Access Compliance Report

Public Rights-of-Way

(Pedestrian Signals)

Intersection ID: N/A	Main Street:	Cross Street: N/A	Location: N/A
ADA ID: D0E2F2CE5587	Signal Type: One Push Button-APS	Overall Compliance: No	Severity Score: BTN 1: N/A BTN 2: N/A No BTN: N/A
Codes/Mitigation Info/Possible Solution		Field Measurements/Component Compliance

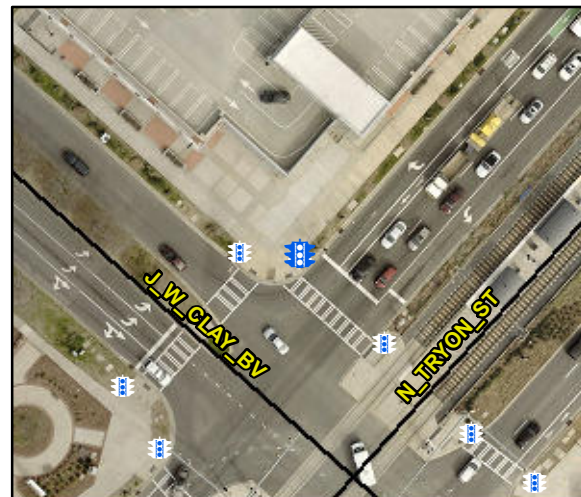
Compliance	Description	Data	Compliance	Description	Data
	Button Count	Button1	Yes	Distant to Additional Button (in)	290.0
	Additional Button Present?	Yes		Additional Button ID	F47C341D39C7
N/A	Signal Buttons Required?	N/A	N/A	Additional Ped Posts Required	N/A
	How Many Ped Street Xings?	N/A		Located In An Island/Median?	N/A
N/A	B 1 Sign Present?	Yes	N/A	B 2 Sign Present?	N/A
Yes	B 1 Sign Purpose?	Yes	N/A	B 2 Sign Purpose?	N/A
Yes	B 1 Sign Lettering & Contrast?	Yes	N/A	B 2 Sign Lettering & Contrast?	N/A
Yes	B 1 Parallel To XWalk?	Yes	N/A	B 2 Parallel To XWalk?	N/A
Yes	B 1 PAR to Button?	Yes	N/A	B 2 PAR to Button?	N/A
Yes	B 1 PAR to XWalk?	Yes	N/A	B 2 PAR to XWalk?	N/A
Yes	B 1 Clear Floor Space?	Yes	N/A	B 2 Clear Floor Space?	N/A
N/A	B 1 FWD Approach?	No	N/A	B 2 FWD Approach?	N/A
N/A	B 1 FWD Approach Constrained?	N/A	N/A	B 2 FWD Approach Constrained?	N/A
N/A	B 1 FWD Approach Reach (in)	N/A	N/A	B 2 FWD Approach Reach (in)	N/A

N/A	B 1 FWD Approach Width (in)	N/A	N/A	B 2 FWD Approach Width (in)	N/A
N/A	B 1 FWD Approach Obstruction?	Yes	N/A	B 2 FWD Approach Obstruction?	N/A
N/A	B 1 FWD Approach Obstruction Dist (in)	3.0	N/A	B 2 FWD Approach ObstructionDist (in)	N/A
N/A	B 1 PARA Approach?	Yes	N/A	B 2 PARA Approach?	N/A
N/A	B 1 PARA Approach Constrained?	Yes	N/A	B 2 PARA Approach Constrained?	N/A
Yes	B 1 PARA Approach Reach (in)	10.0	N/A	B 2 PARA Approach Reach (in)	N/A
No	B 1 PARA Approach Width (in)	48.0	N/A	B 2 PARA Approach Width (in)	N/A
N/A	B 1 PARA Approach Obstruction?	Yes	N/A	B 2 PARA Approach Obstruction?	N/A
N/A	B 1 PARA Approach Obstruction Dist (in)	3.0	N/A	B 2 PARA Approach ObstructionDist (in)	N/A
No	B 1 Clear Floor Space Slope (%)	4.4	N/A	B 2 Clear Floor Space Slope (%)	N/A
No	B 1 Clear Floor Space XSlope (%)	4.5	N/A	B 2 Clear Floor Space XSlope (%)	N/A
N/A	B 1 PAR Slope (%)	N/A	N/A	B 2 PAR Slope (%)	N/A
Yes	B 1 Height (in)	36.0	N/A	B 2 Height (in)	N/A

Possible Solutions: Remove & Replace
Replace APS Button With New APS Button.
Remove and Replace Clear Space.
